CITY OF NORTH OAKS

Regular Planning Commission Meeting

PLANNING REPORT

RE: North Oaks - East Oaks Planned Unit Development
Nord Preliminary Plan (Subdivision)

Exhibit E: Existing Conditions

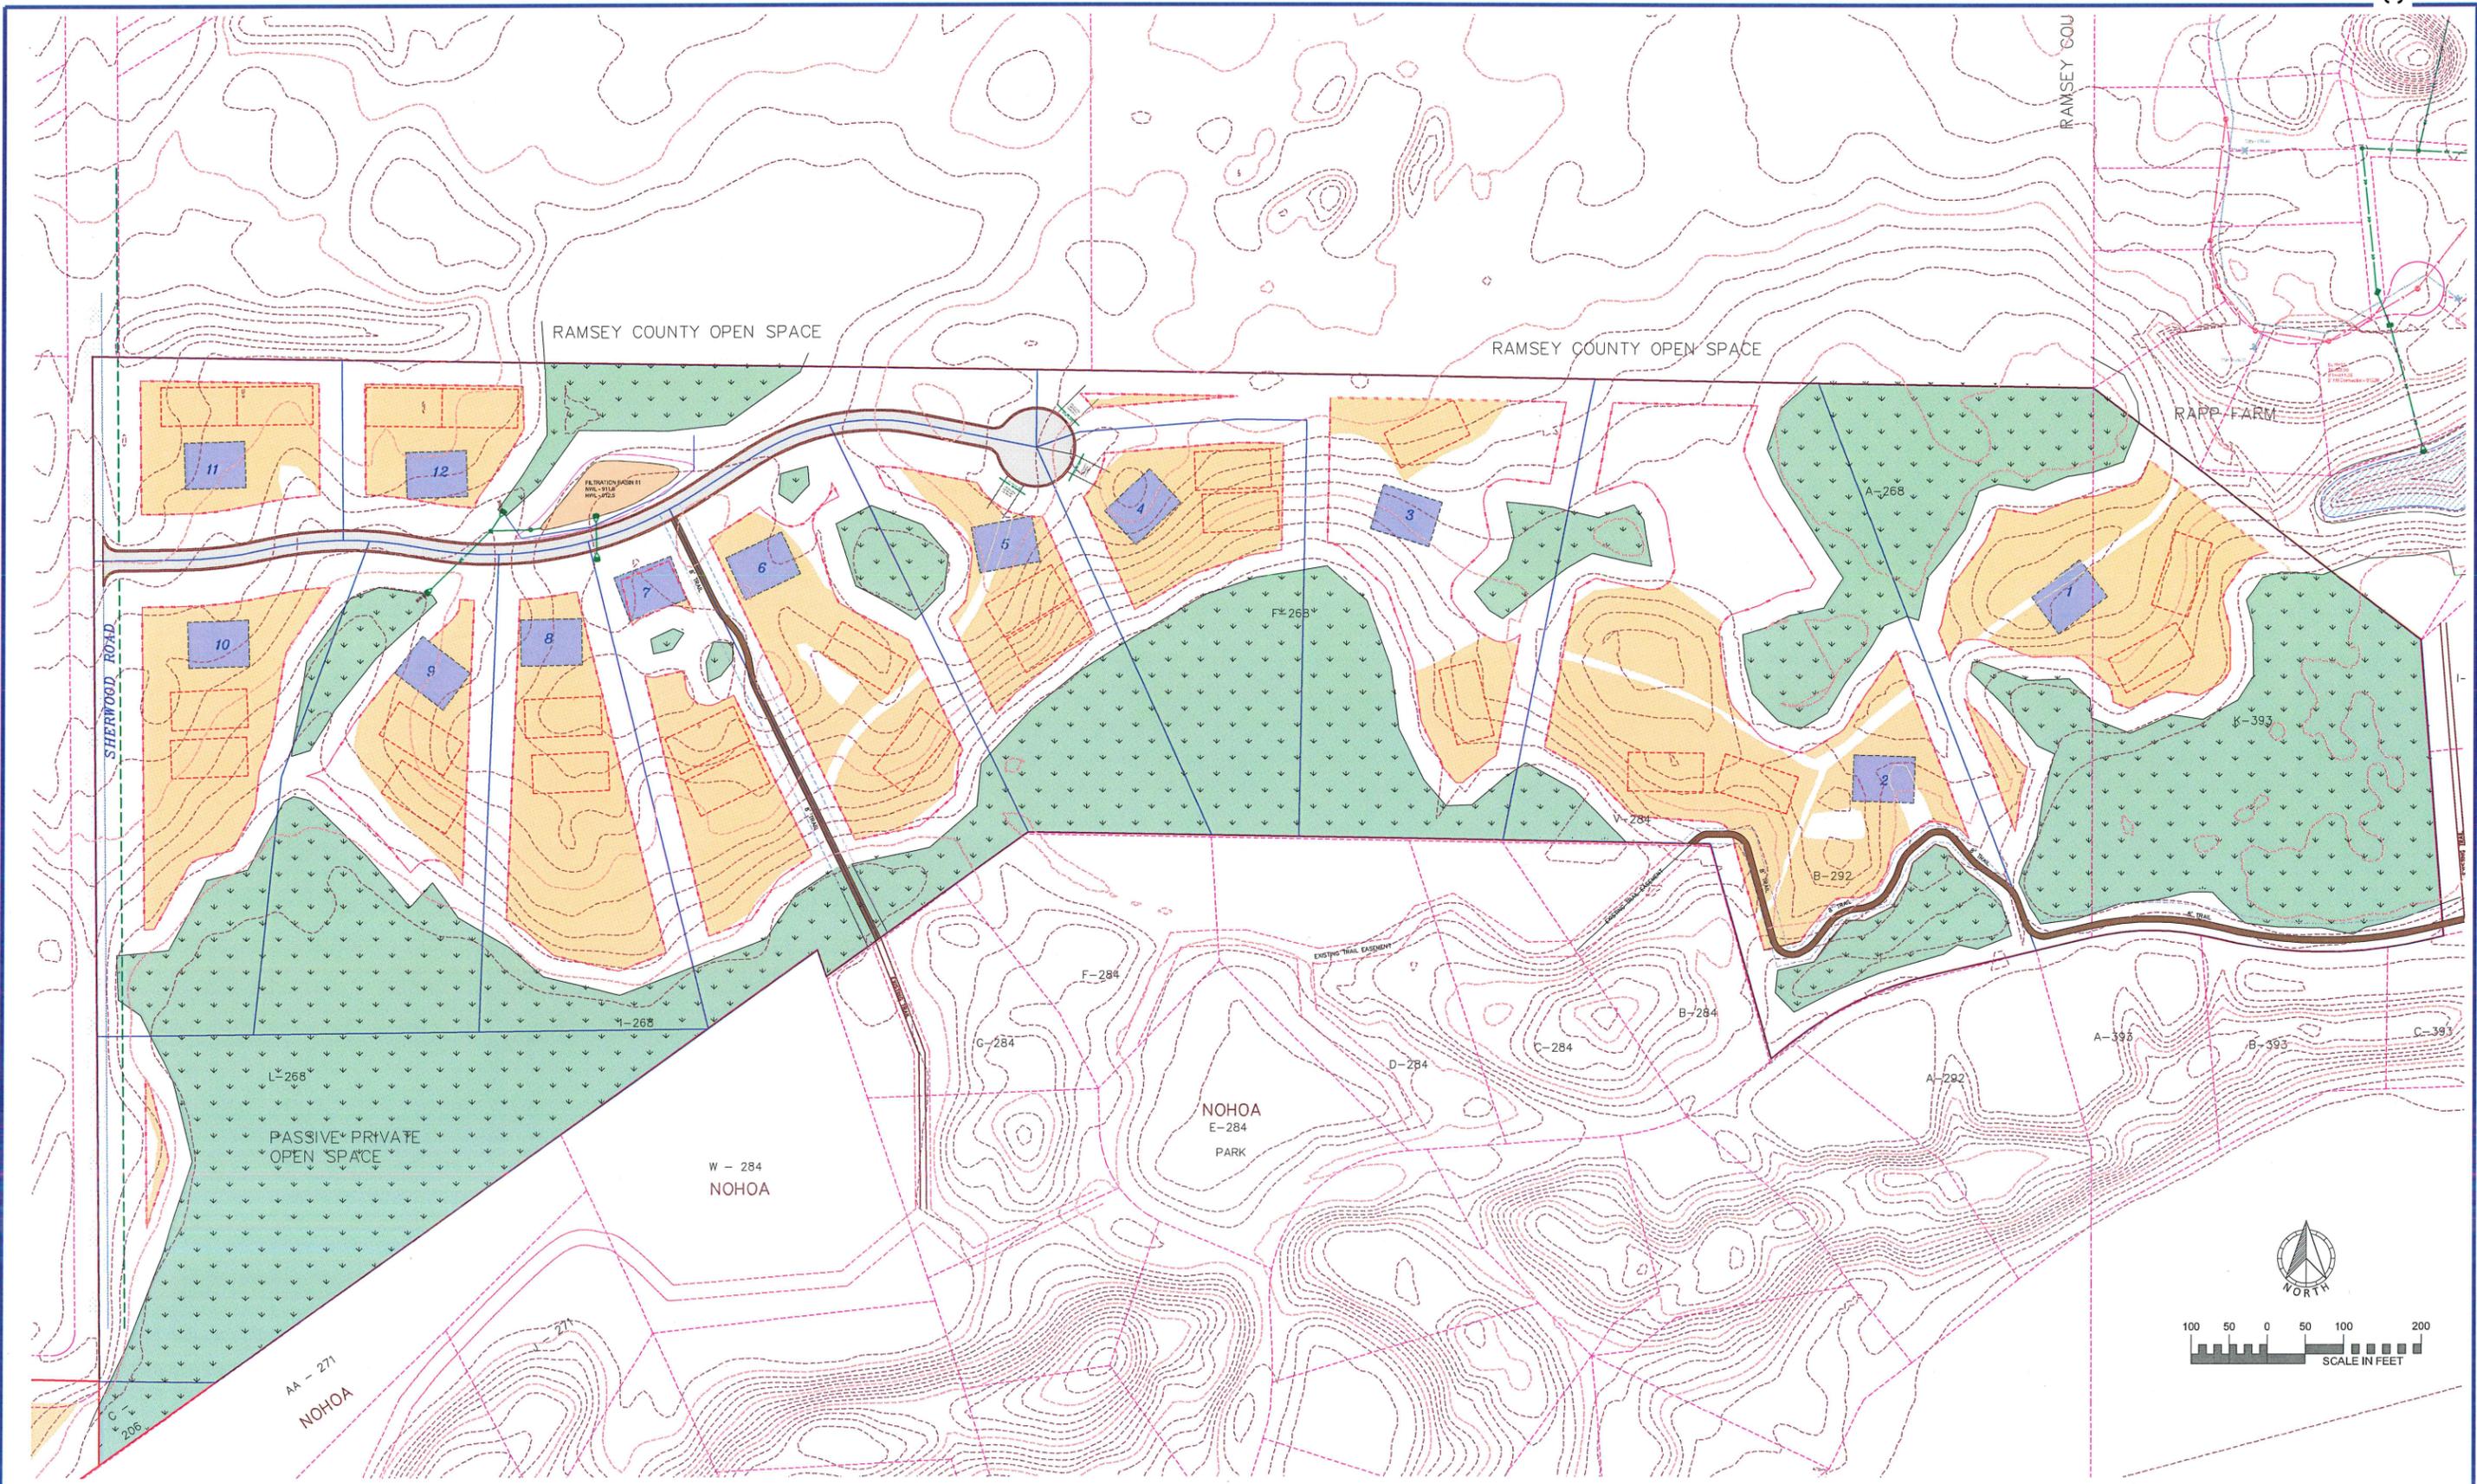
6. Existing conditions plan shall include field verification dates for topographic survey.
7. Proposed trail connection across Lots 1 & 2 from the Existing Trail Easement appears to cross/conflict with proposed shared access driveway for Lots 1 & 2. Details of this crossing/conflict should be included in final construction plans.

Exhibit I: Preliminary Grading Plan

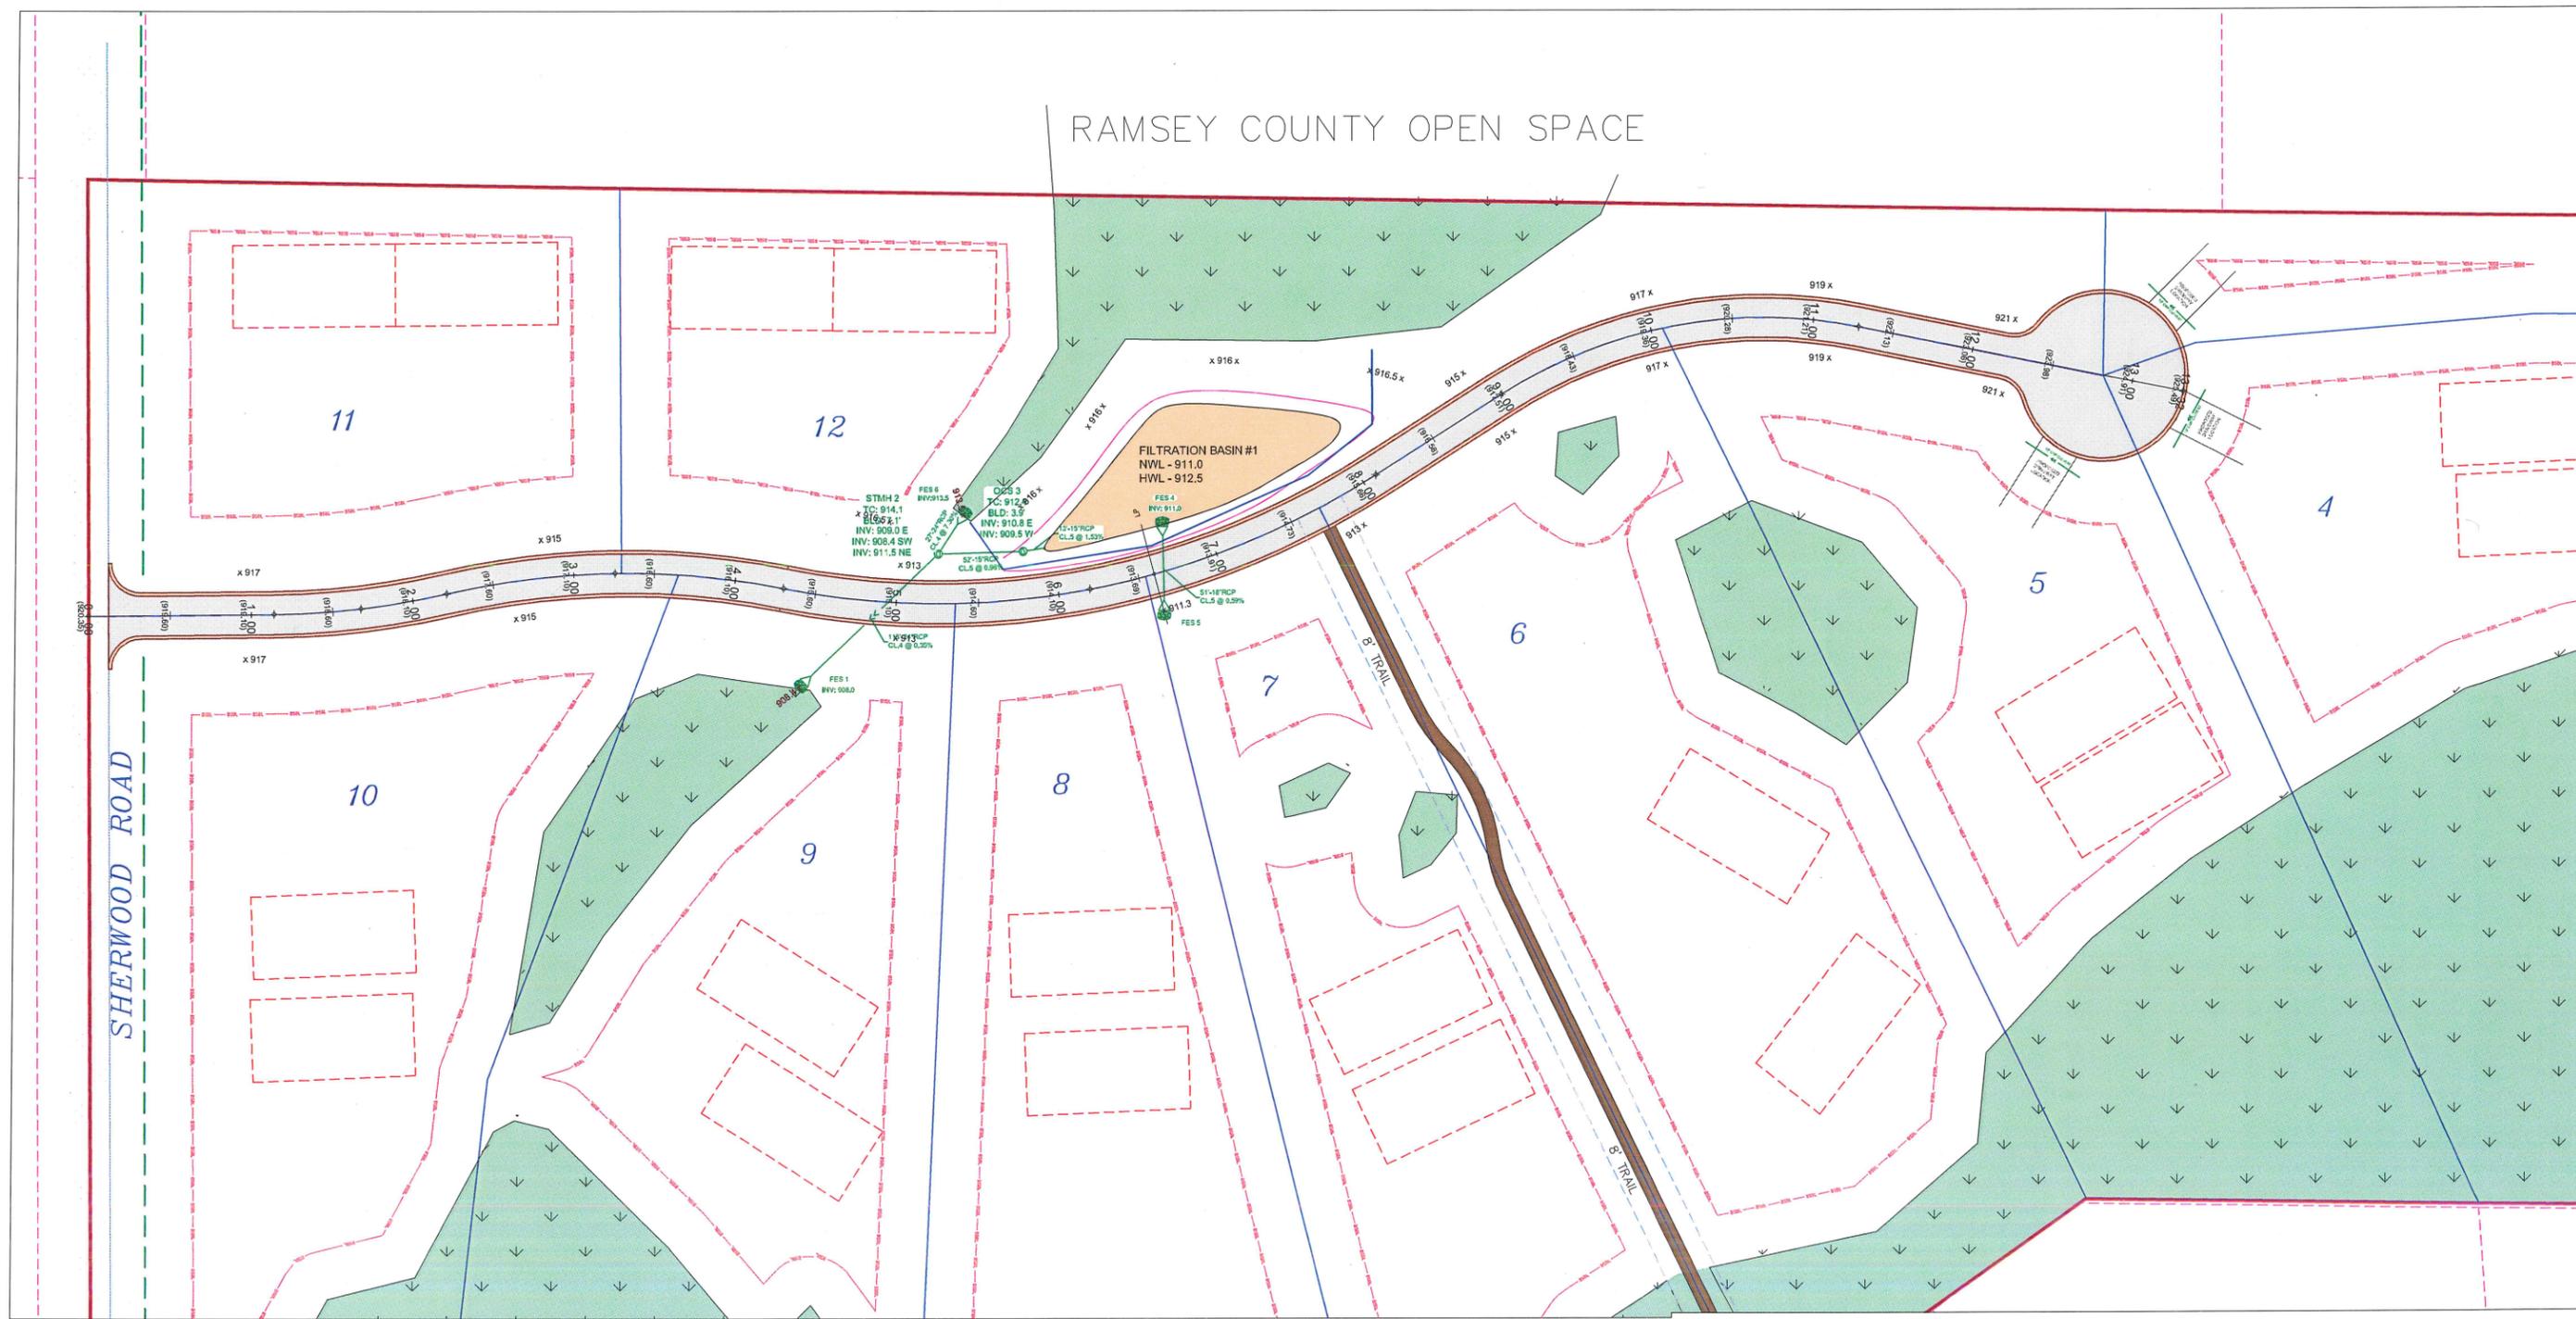
9. The preliminary grading plan illustrates proposed longitudinal slopes of approximately 1 percent in the street ditch section in a few locations. In areas where the ditch will be maintained by the homeowner, a drain tile system is recommended to be installed in ditch sections with proposed slopes less than 2 percent, if the existing soil condition is not free draining.

10. A 2-foot separation shall be shown from the edge of the shoulder to the finished grade around the perimeter of the cul-de-sac on the final construction plan. The 2-foot separation shall be provided at 8 feet from the edge of the shoulder.

11. A 10-foot maintenance bench shall encompass the stormwater ponds and shall be shown on the final grading construction plan.
12. A grading plan for each "custom" lot shall be submitted with each building permit application. Proposed grades around the perimeter of the proposed homes shall meet the requirements of the state building code. Staff recommends that a minimum driveway slope of 3 percent, and a maximum of 10 percent. Details of proposed driveway sections over drainage ditch with proposed culverts shall be included in plans for building permit review to ensure grading and drainage plan is maintained.

13. Final grading plan should include high point elevations, grade breaks, typical slopes and drainage arrows.
14. Final construction plans shall include locations and details for all proposed site sedimentation and erosion control BMPs, including plans for temporary stormwater management BMPs and protection of permanent BMPs during construction.

Exhibit K: Preliminary Landscape / Sign Plan

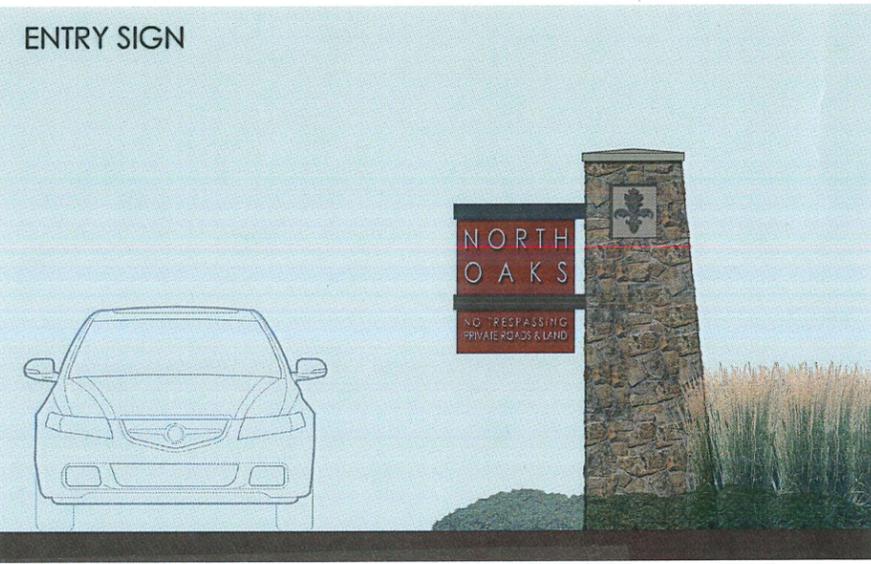
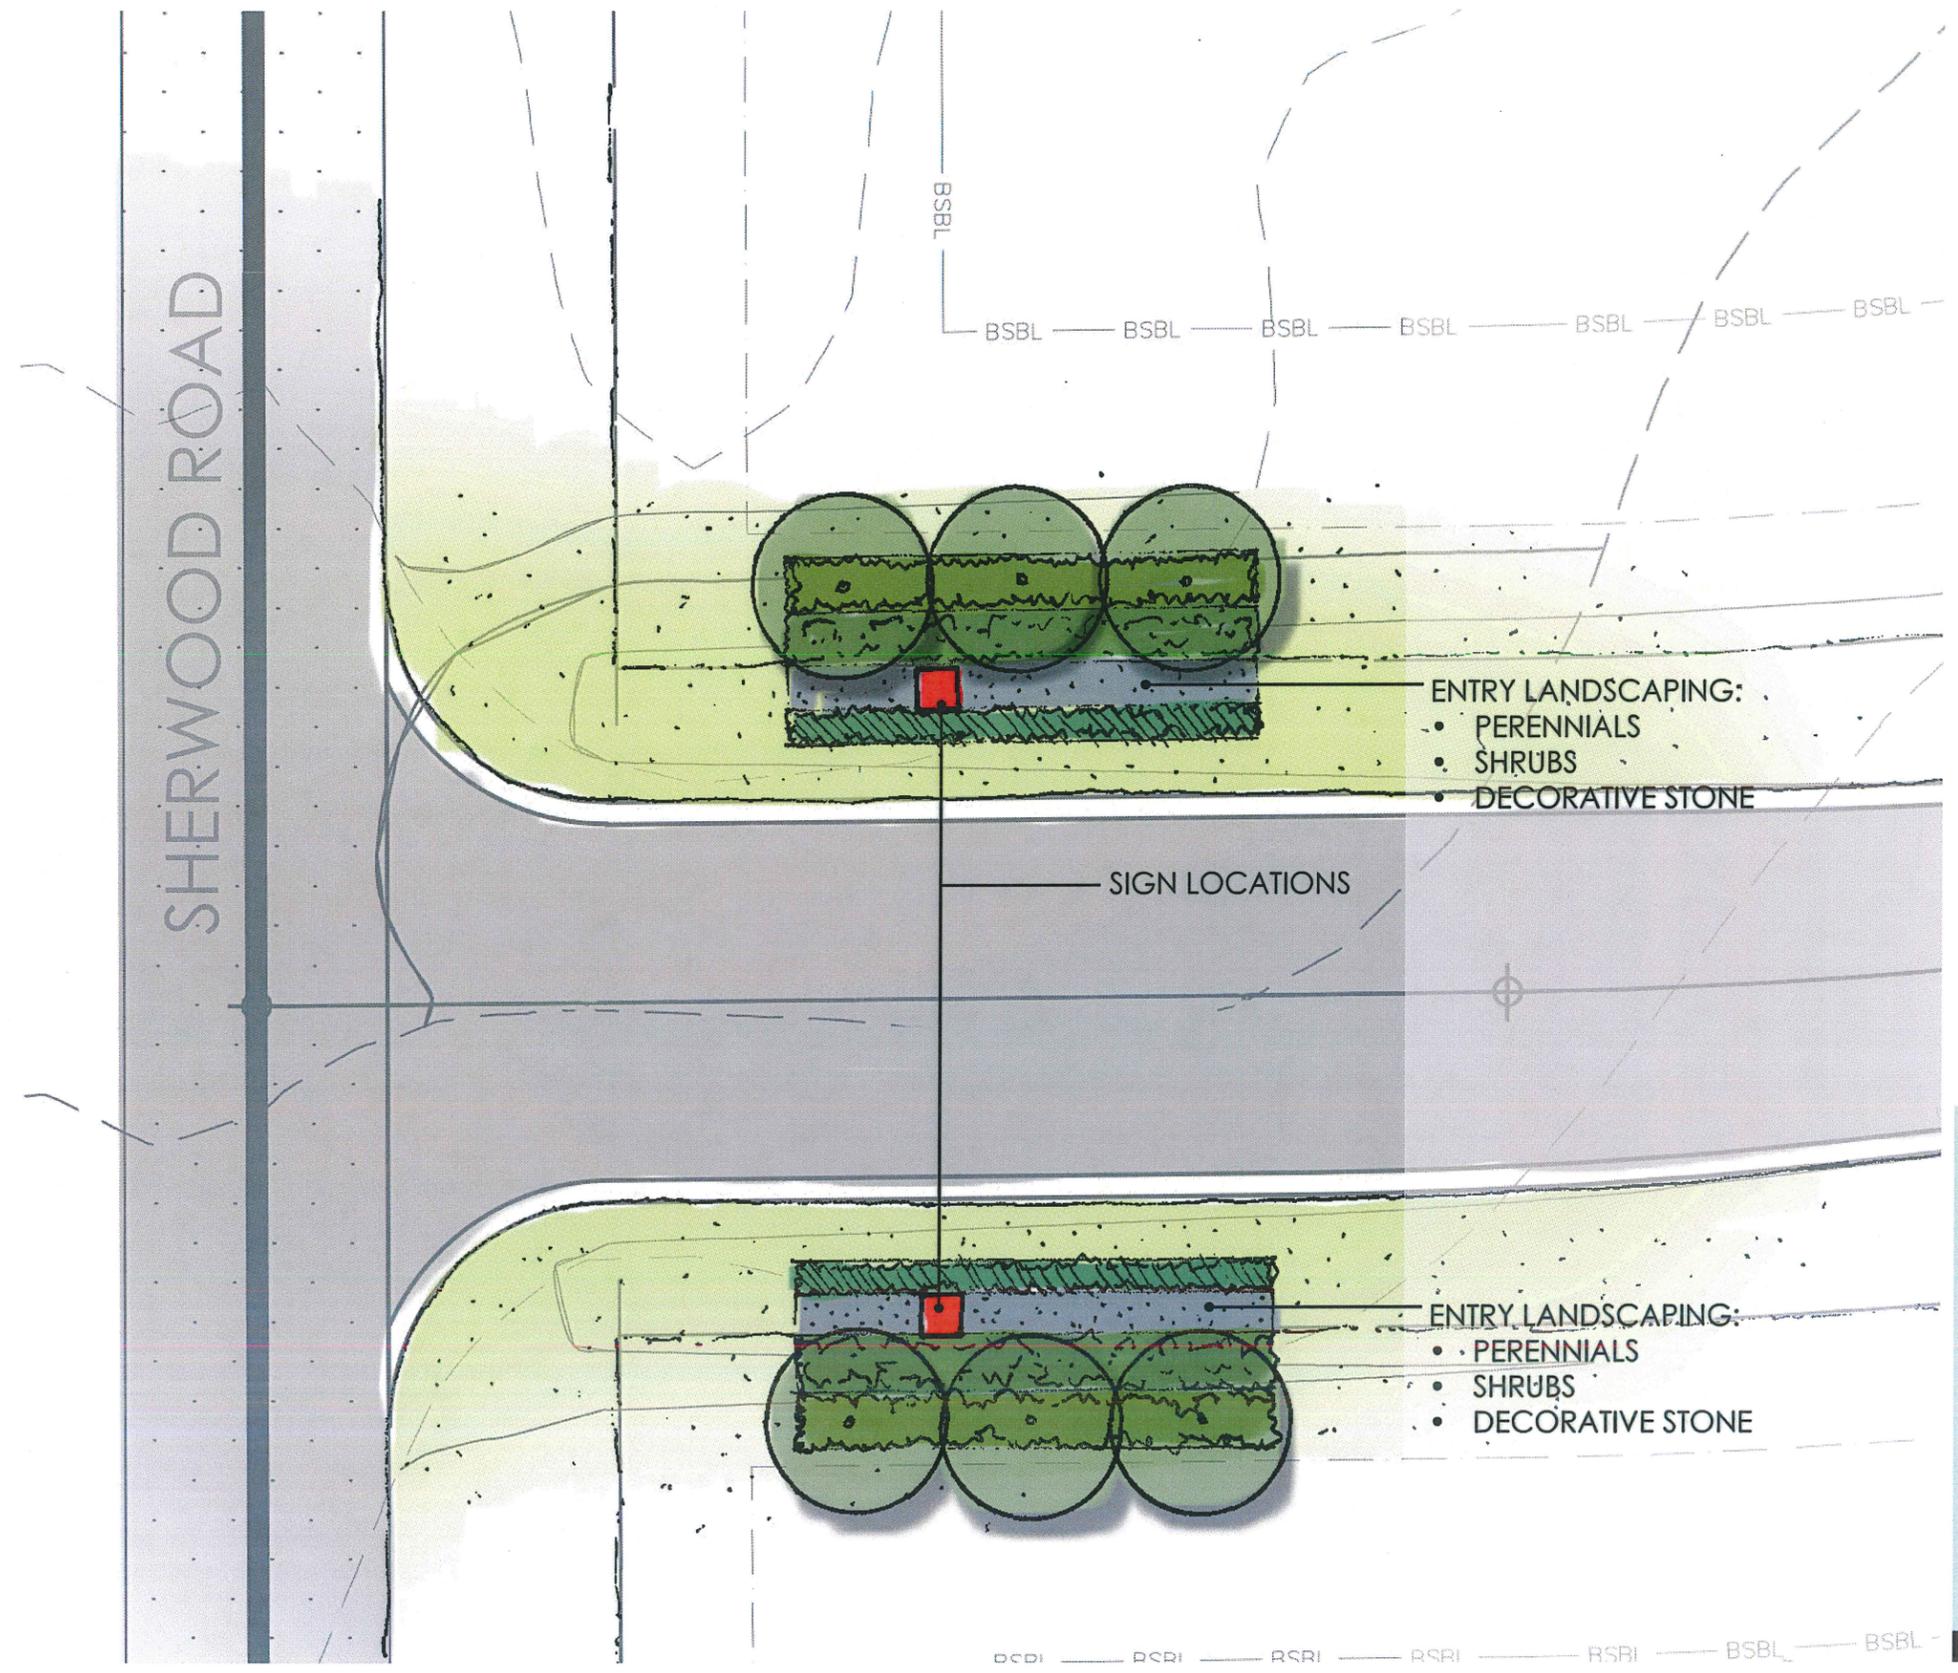
While the proposed monument sign appears to meet the preceding PDA requirements, additional detail (sign and setback dimensions) is necessary to make a final determination. As a condition of final subdivision approval, it is recommended that the proposed monument sign meet the preceding PDA requirements.

5. The plans be amended to reflect the proposed final trail developed in concert with NOHOA.
6. The proposed monument sign shall satisfy the following conditions:
